## Product change

### EPCOS aluminum electrolytic capacitors with screw terminals

150327ALU1e

## Product / Process Change Notification

**Illustration of new and old cover disk for terminals with a diameter of 8 mm**

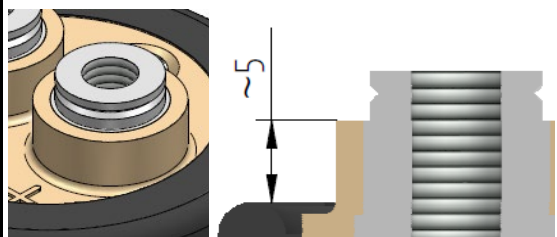
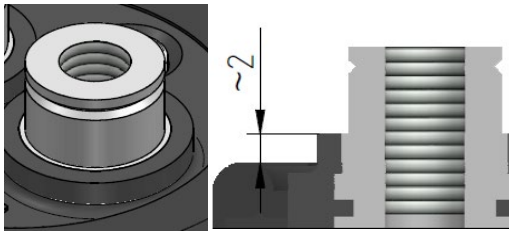
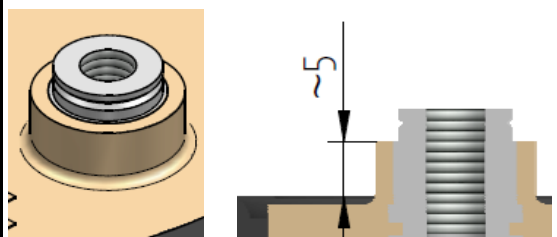
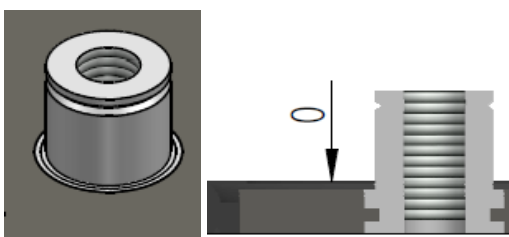
The only exceptions concern types with a terminal diameter of 8 mm: The step around the terminals was reduced in height or eliminated altogether.

Remark: Change of molded part around the terminals; for affected series and ordering codes, see Annex 2

Old design	New design
Capacitor diameter 35 mm		
Capacitor diameter 50...90 mm
